Pentium[®] II Processor Specification Update

Release Date: January 26, 1998

Order Number: 243337-010

NOTES FOR FIGURE 1 THROUGH FIGURE 11

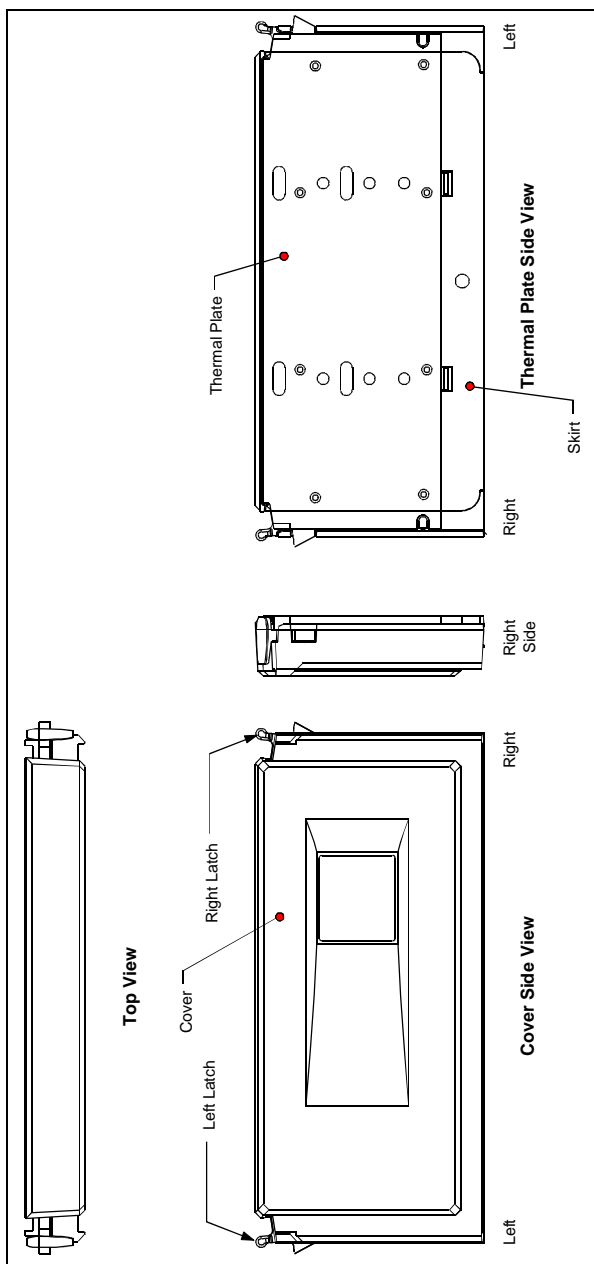
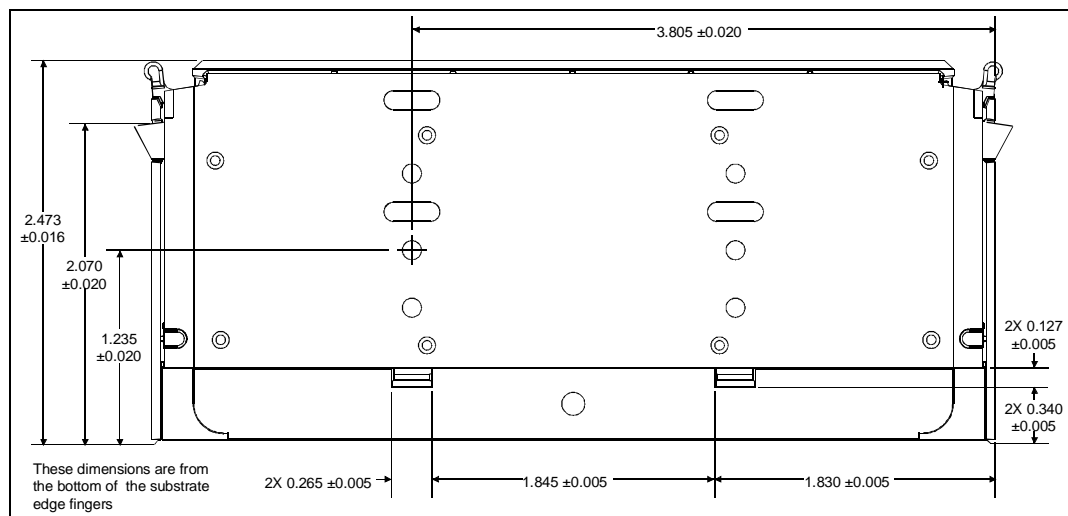
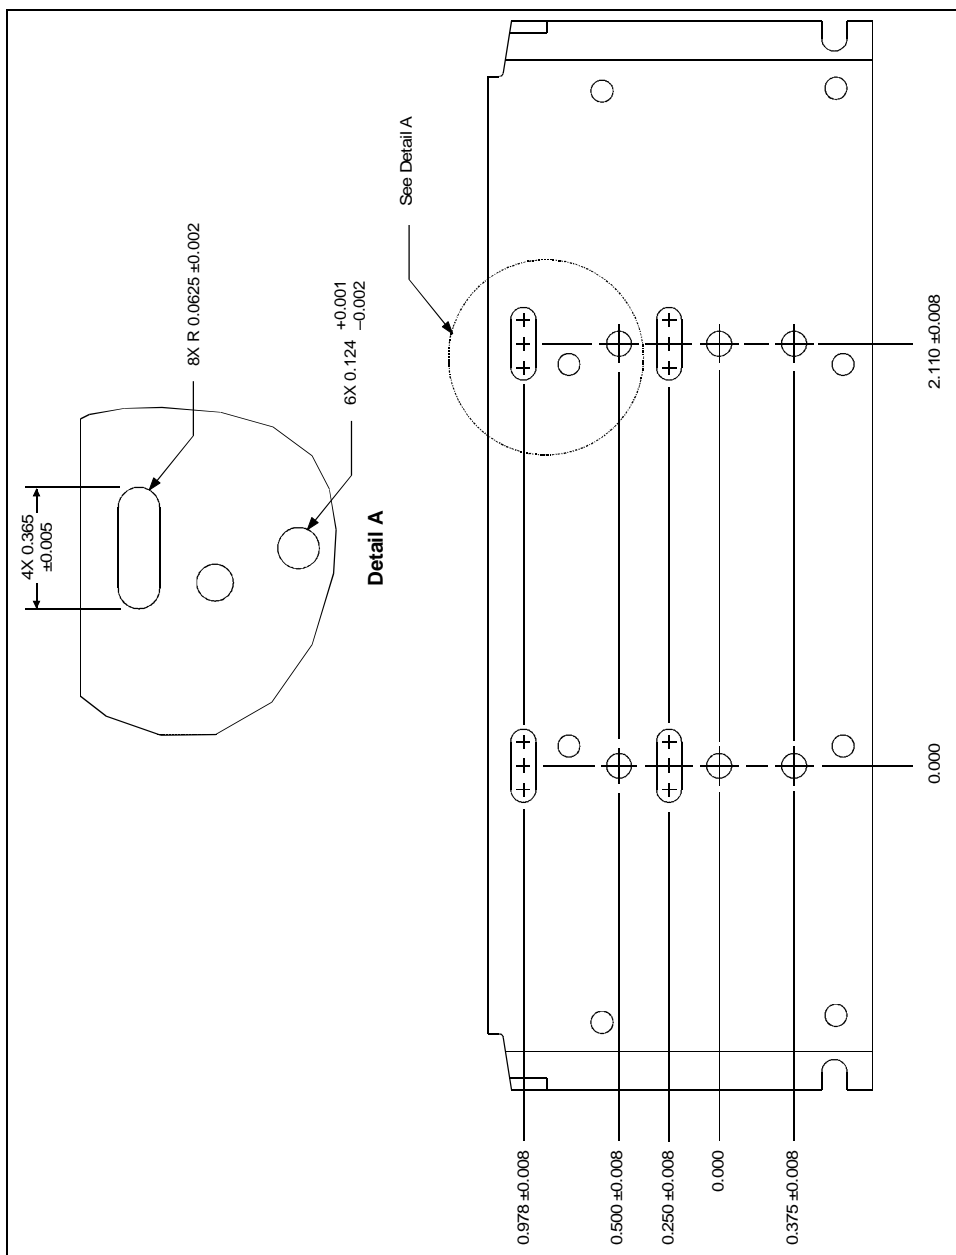
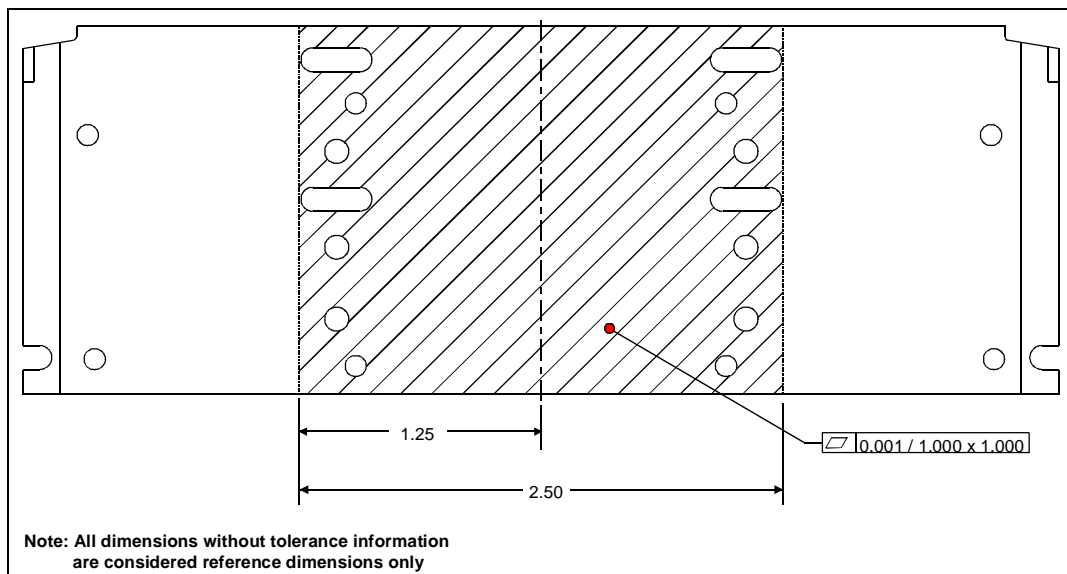
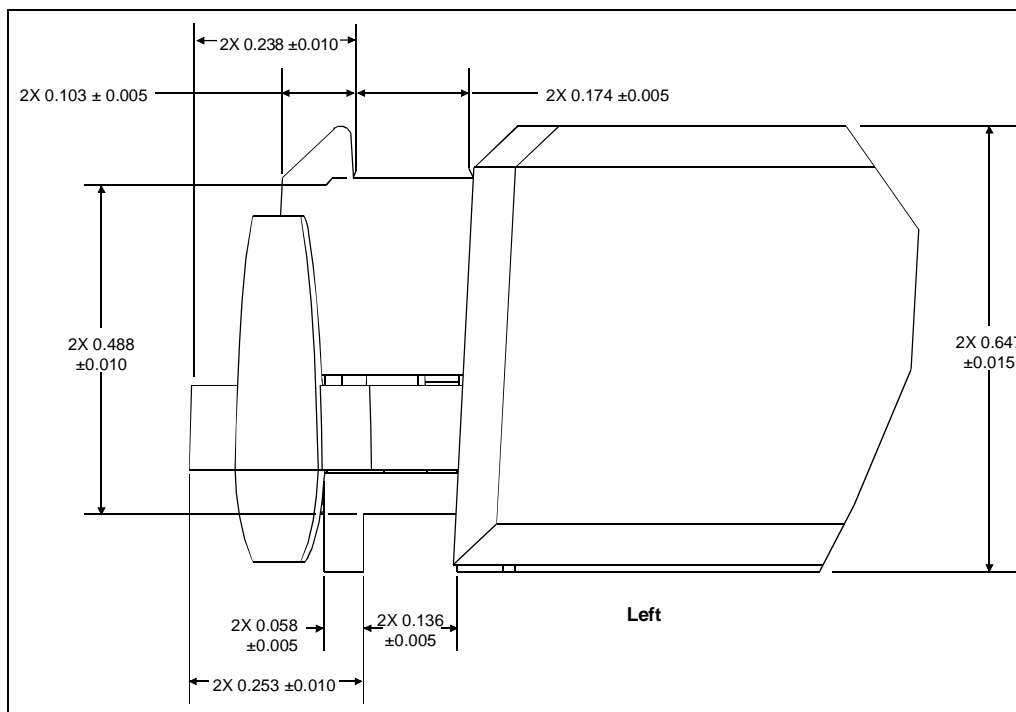
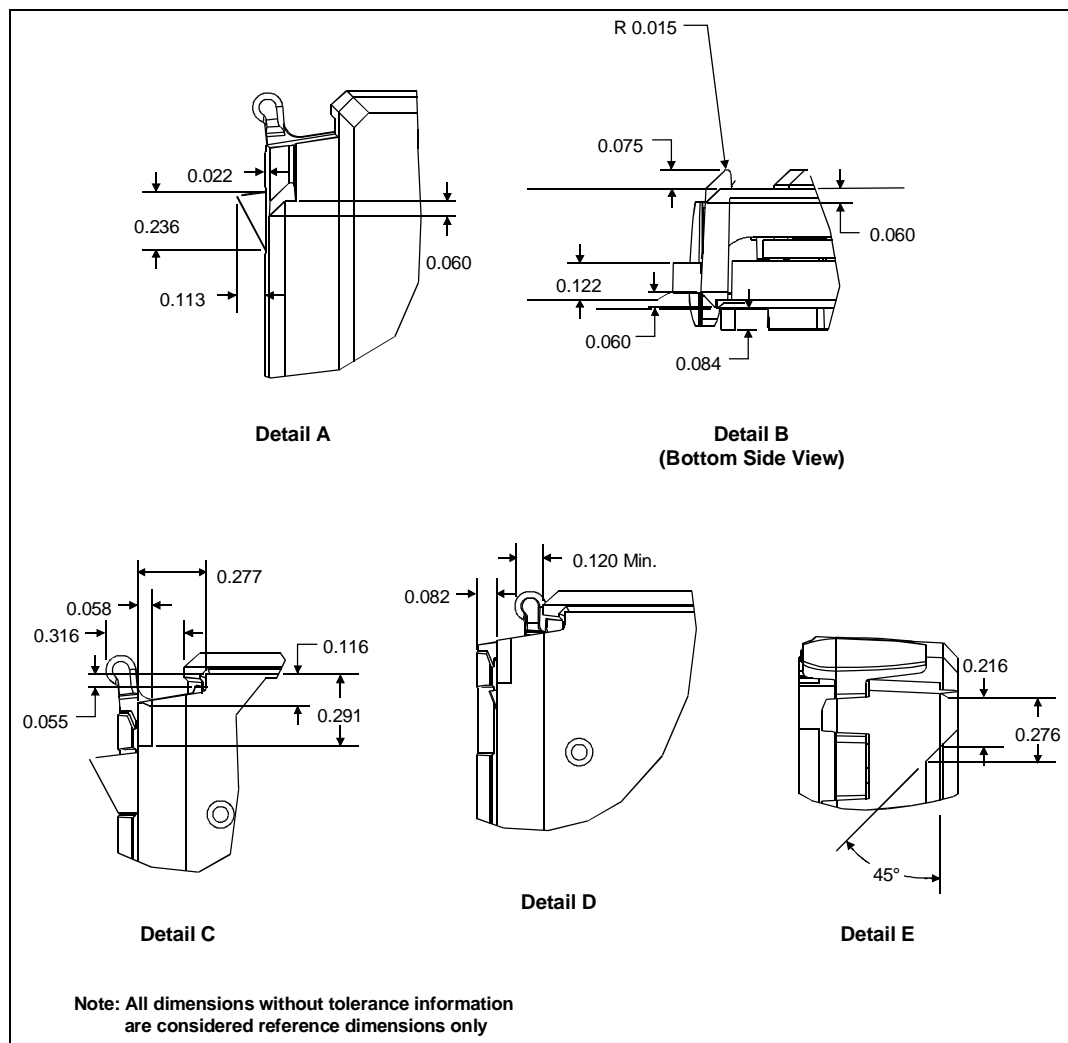
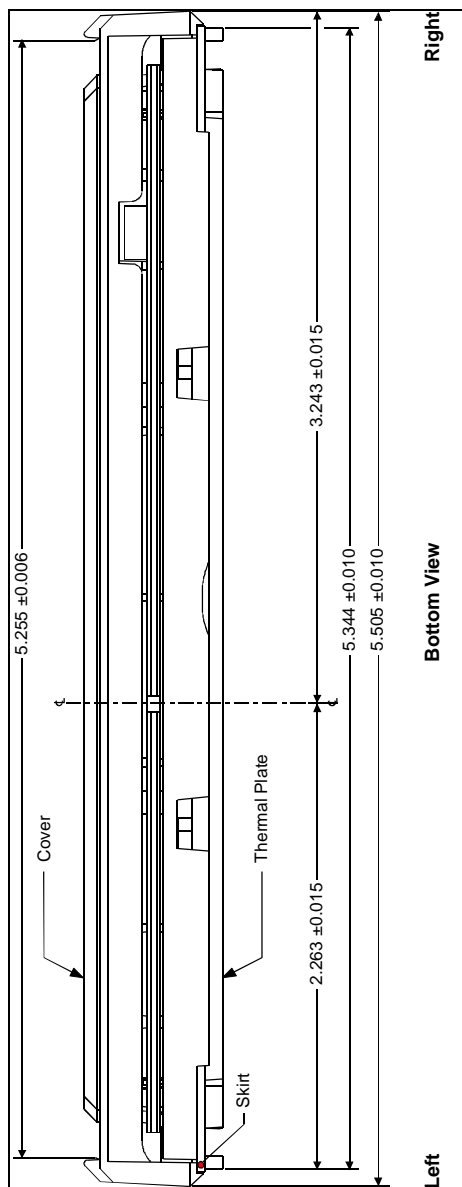
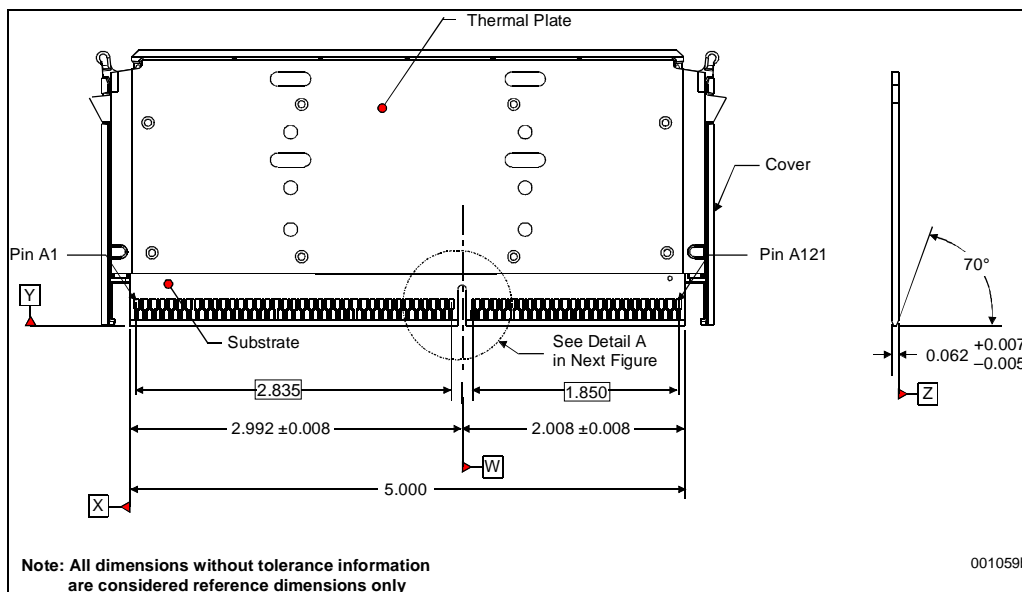
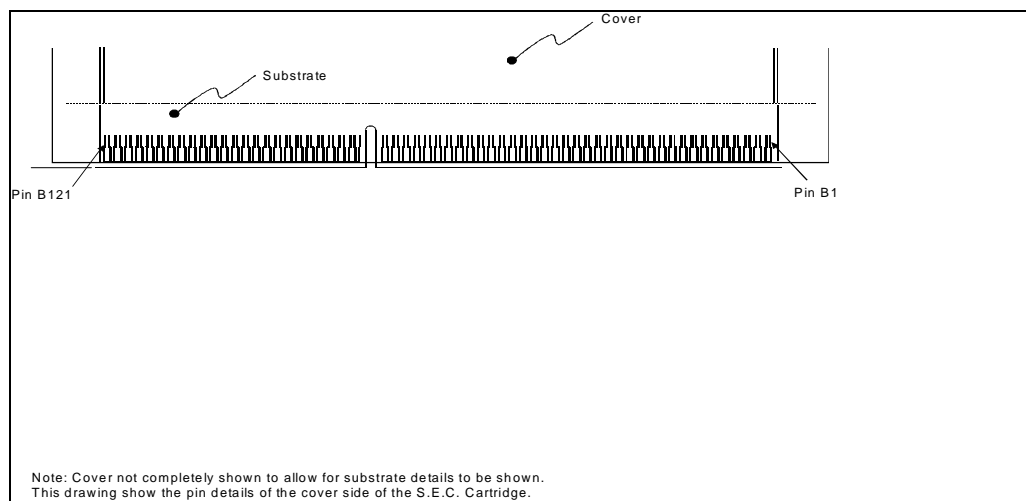
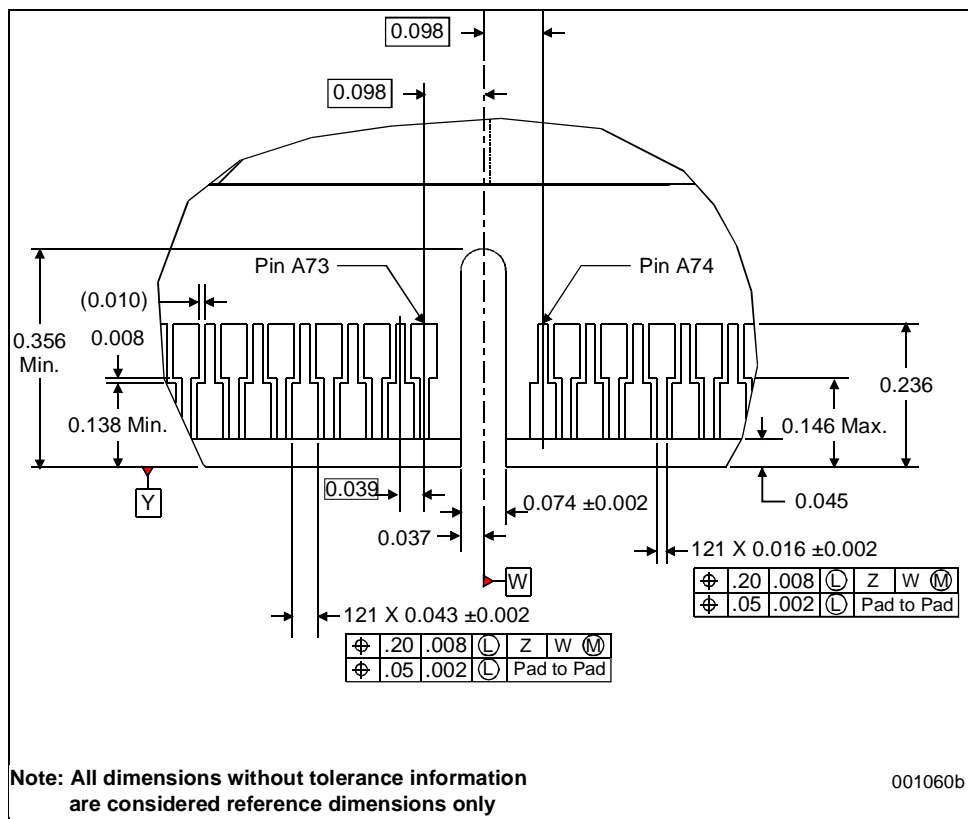
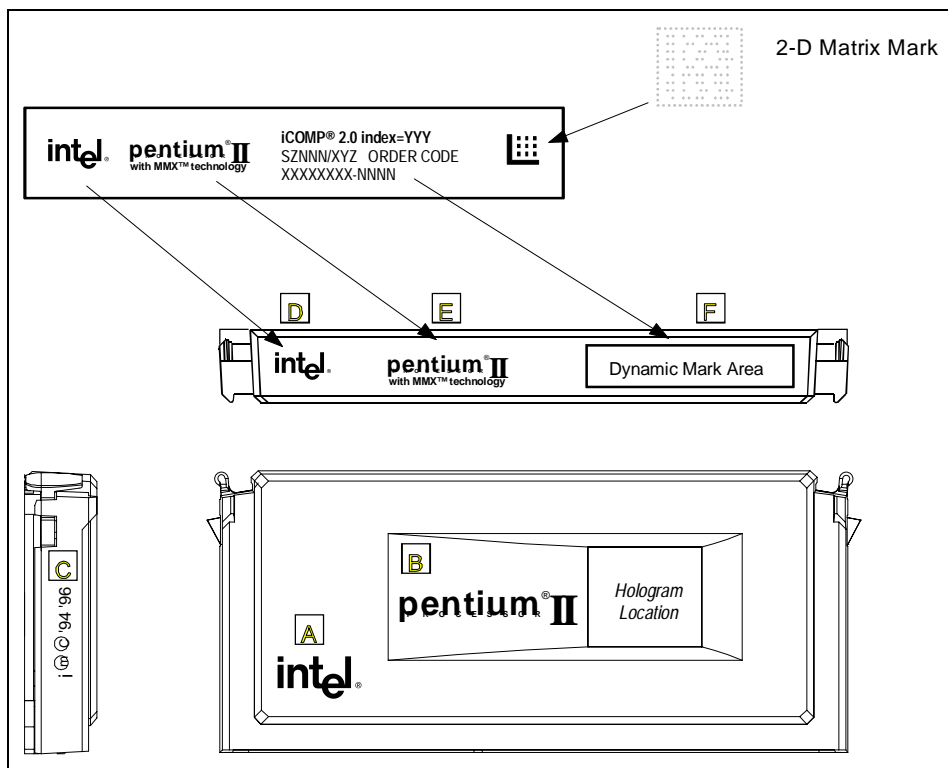
The S.E.C. cartridge mechanical specifications provided in the *Pentium® II Processor at 233 MHz, 266 MHz and 300 MHz* datasheet contained incorrect tolerance information for some dimensions. Also, some of the information provided in the figures was duplicitous and not required to accurately use and design for the S.E.C. cartridge package. The revised figures provided in this section are meant to replace Figures 29 through 42, Table 23 and the accompanying notes found on page 44.

Figure 12. Heatsink Attachment Mechanism Design Space

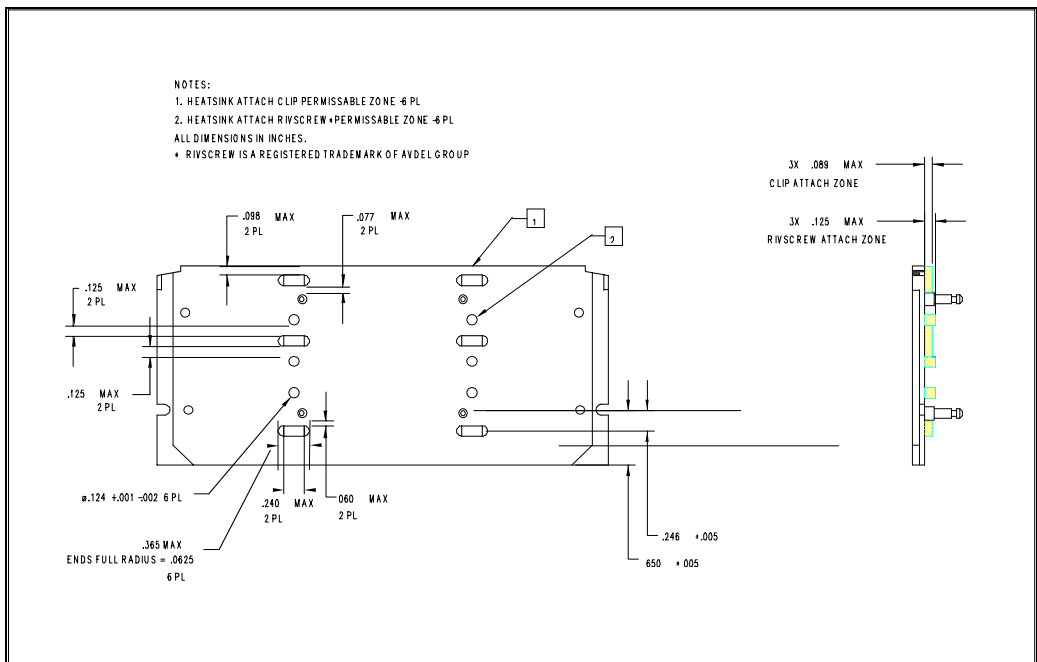
A change to the attach mechanism specification is provided below. The original specification for clearance of heatsink attach solutions is provided in Section 4.3 (and Figure 23 and Figure 24) in the *Pentium® II Processor at 233 MHz, 266 MHz and 300 MHz* datasheet. Figure 11 shows the revised maximum specifications for heatsink clip and RivscREW* attach mechanism designs. All heatsink clip and RivscREW attachment solutions must remain within the respective maximum “permissible” zone as detailed in Figure 11.

The thermal plate shown in Figure 11 is used to portray the heatsink attach mechanism design space for the future Slot 1 processors. However, the maximum “permissible” design space is also valid for both the current Pentium II and future Slot 1 processors.

Please review the proposed specifications to guarantee compatibility with existing Pentium II and future Slot 1 processor heatsink attachment solutions. Note that the required heatsink attachment solution space should not exceed the maximum proposed design space while installed or during the installation and removal procedure.
